Before the
FEDERAL COMMUNICATIONS COMMISSION
Washington, DC 20554

In re Application of)
)
The Association for Community Education, Inc.)
)
For a New FM Translator Station on Channel)
211 in Santa Ana, California)
_____)

File No. BPFT-960910TB
File No. BPFT-970218TE

SUPPLEMENT TO MOTION TO DISMISS OR,
IN THE ALTERNATIVE, PETITION TO DENY

FIGURE 1
SMCCD

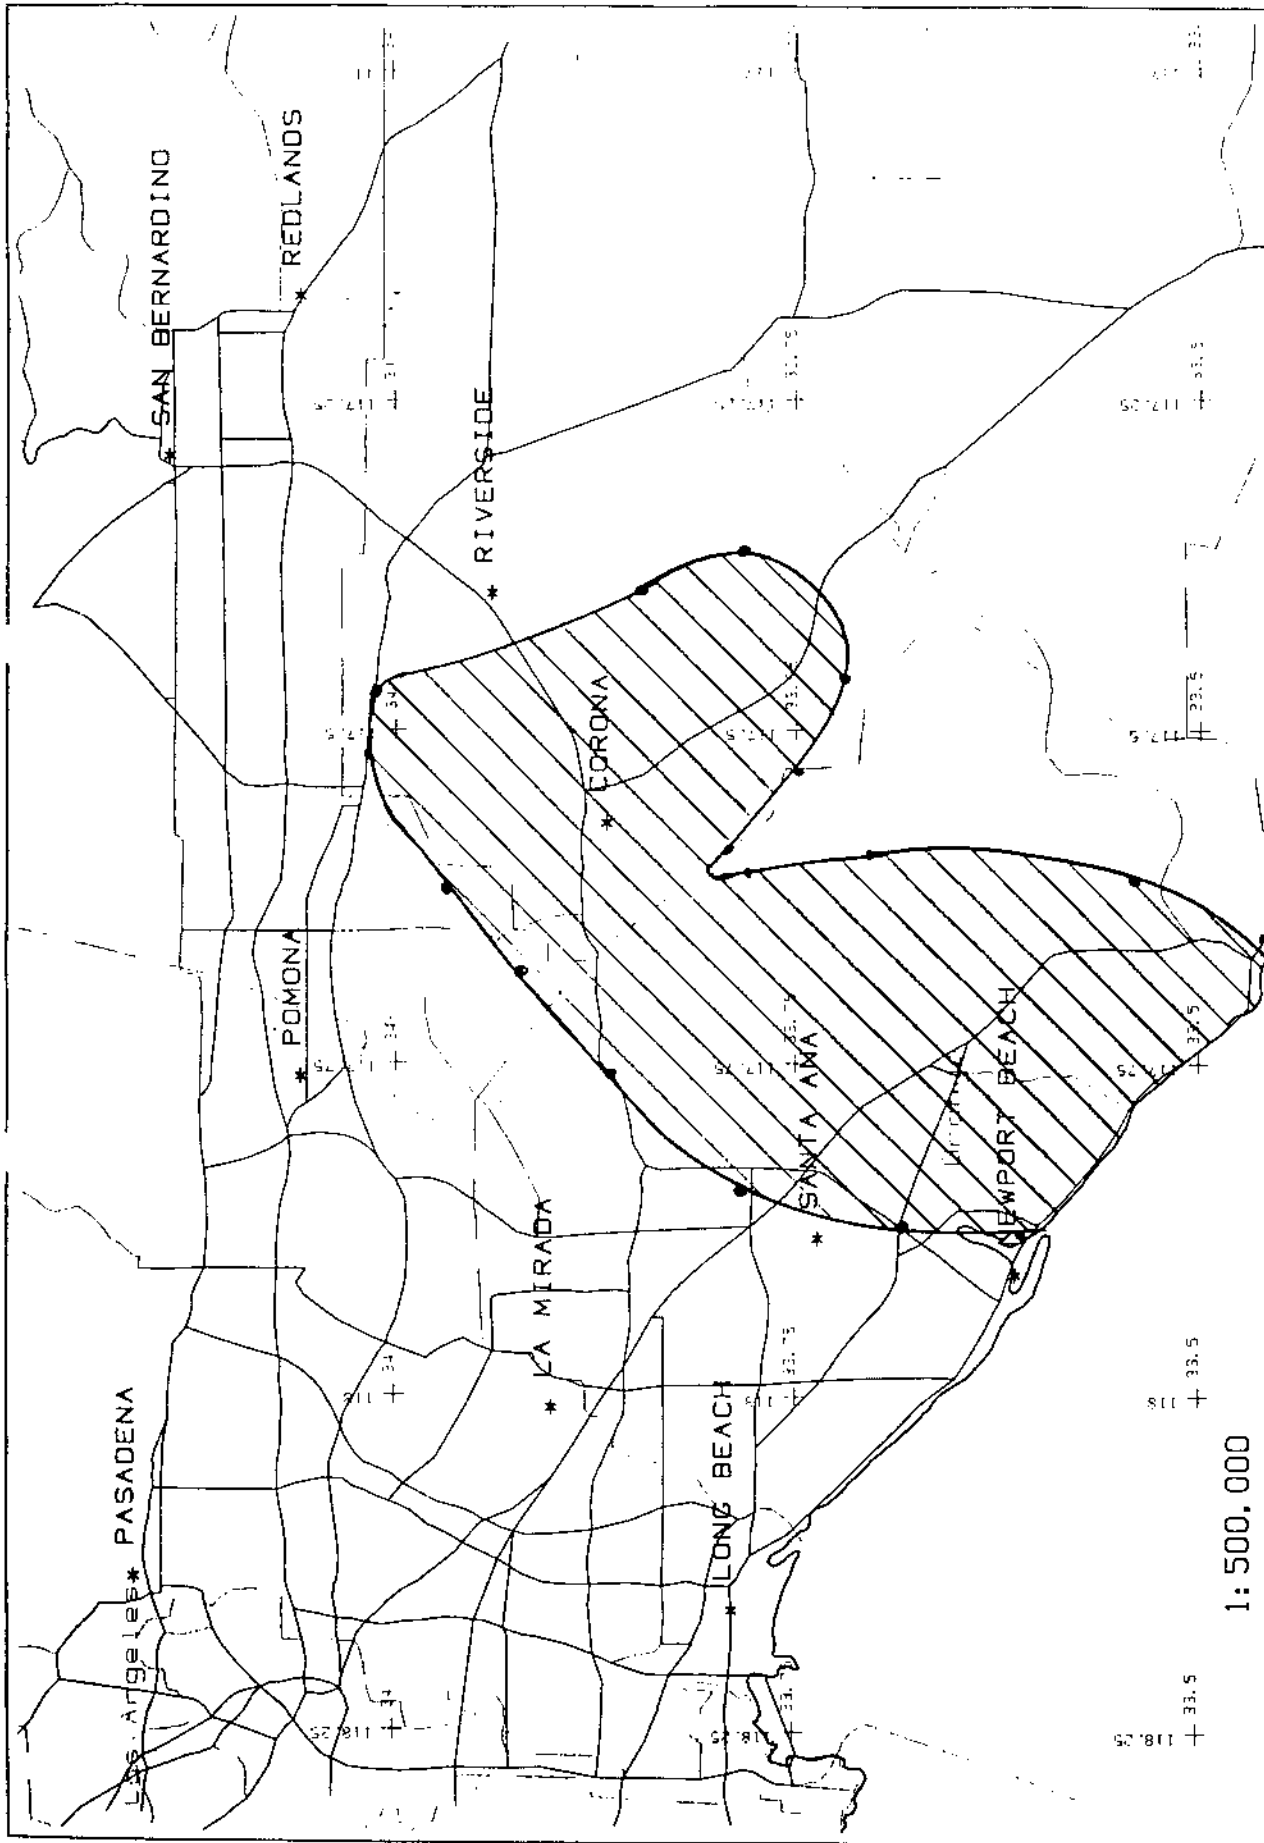
The KCRW signal is regularly received in the Santa Ana area and Community's proposed translator will interfere with the reception of the KCRW signal in this area. Figure 1 shows the interference area¹ around Santa Ana. This interference area was determined to be 1,491 square km and the population within this area is 899,107 persons (1990 Census). The KCRW subscriber database² revealed that within this interference area there are 1,063 subscribers who regularly listen to KCRW. All of these subscribers will be adversely affected by the proposed translator.

6 dB D/U INTERFERENCE AREA CAUSED BY
PROPOSED NEW SANTA ANA TRANSLATOR

EXHIBIT E6 PAGE 3
 CARL E. GLUCK - 02/97

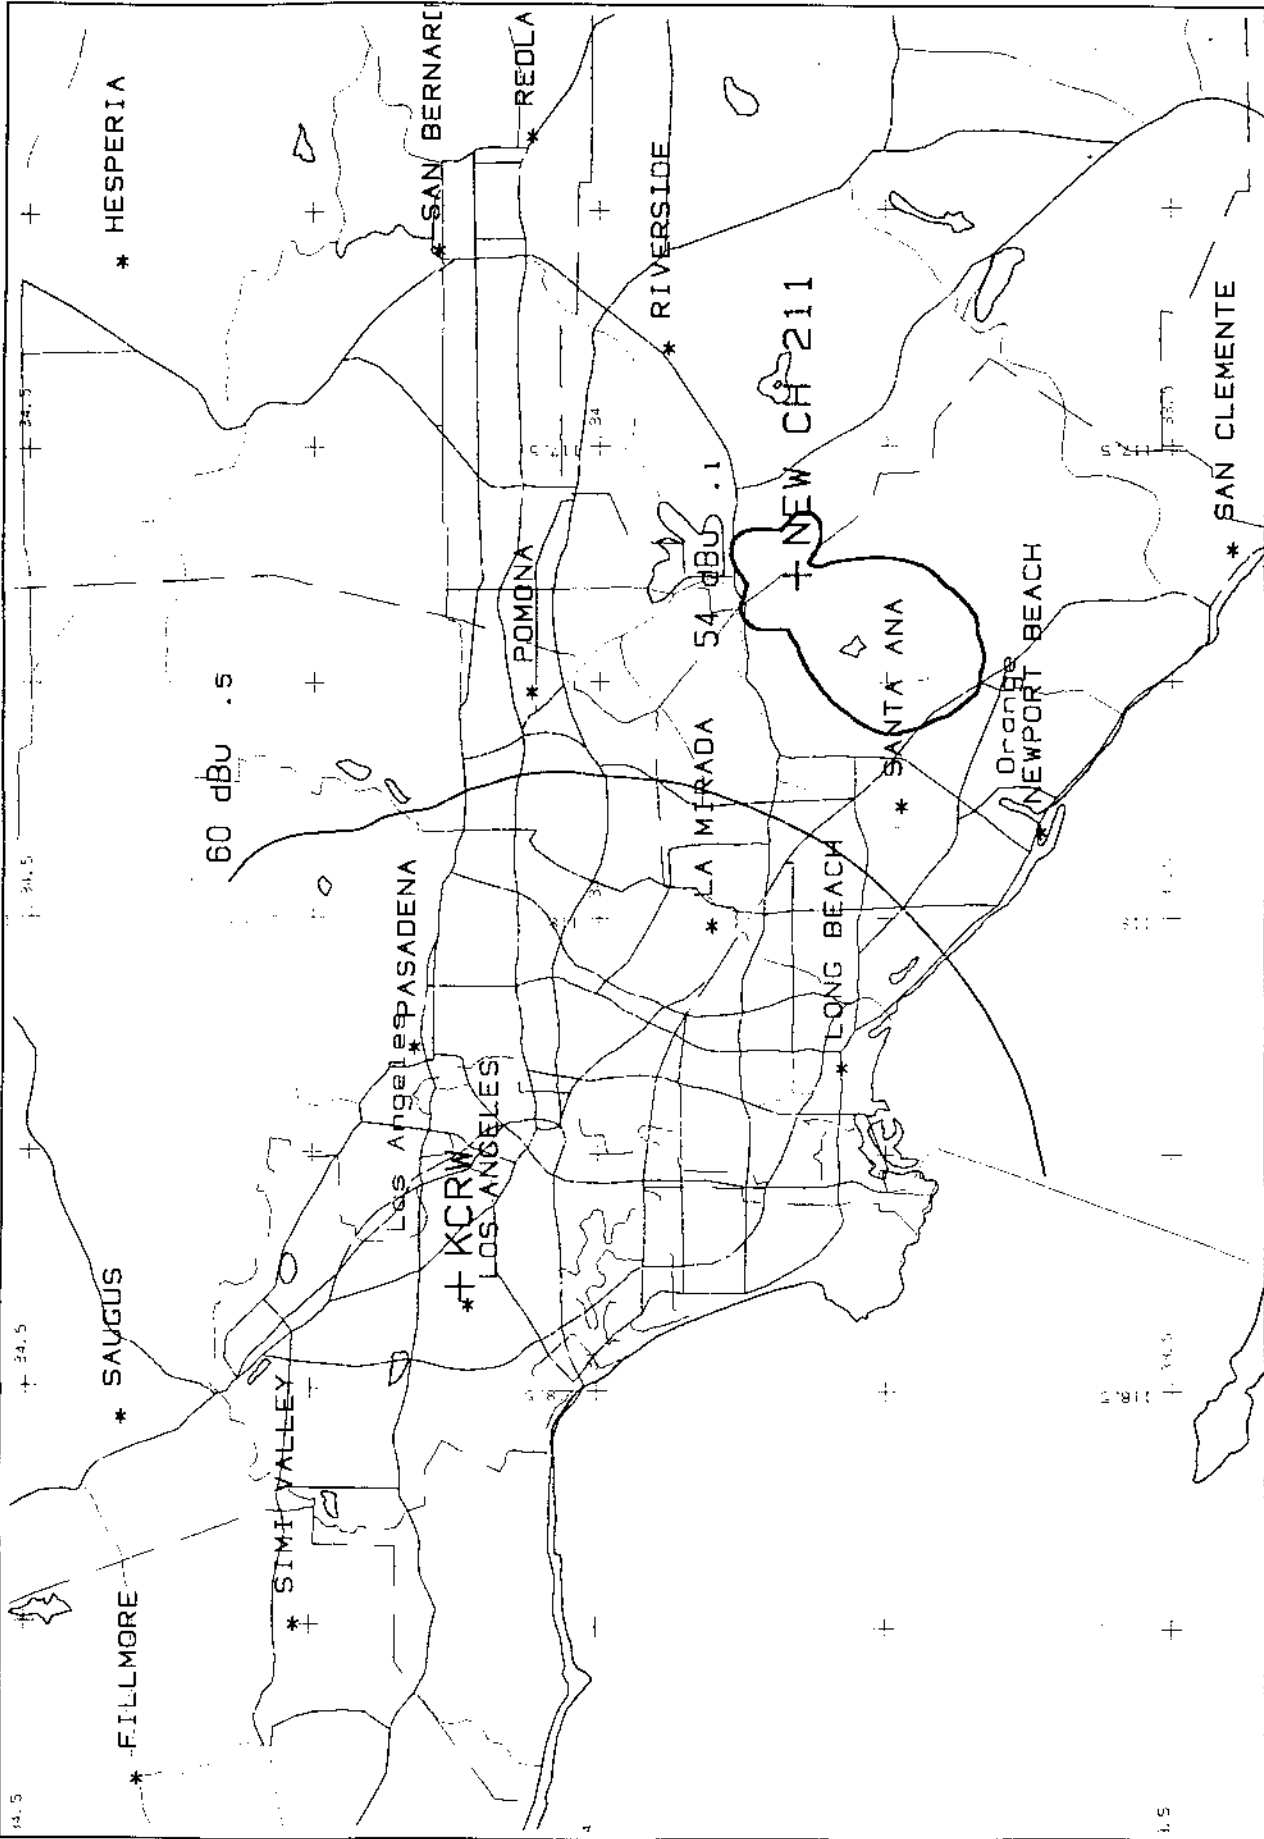
On March 10, 1997, the writer drove through the canyon areas where Community asserts that KCRW cannot be received. It was found that KCRW can be received adequately throughout the area, which further reinforces Santa Monica's assertion that damaging interference to KCRW will result from the granting of Community's amended application.

In summary, Community's proposed FM translator, as amended, will cause interference to the regularly received signal of first adjacent channel station KCRW and, therefore, must be denied.
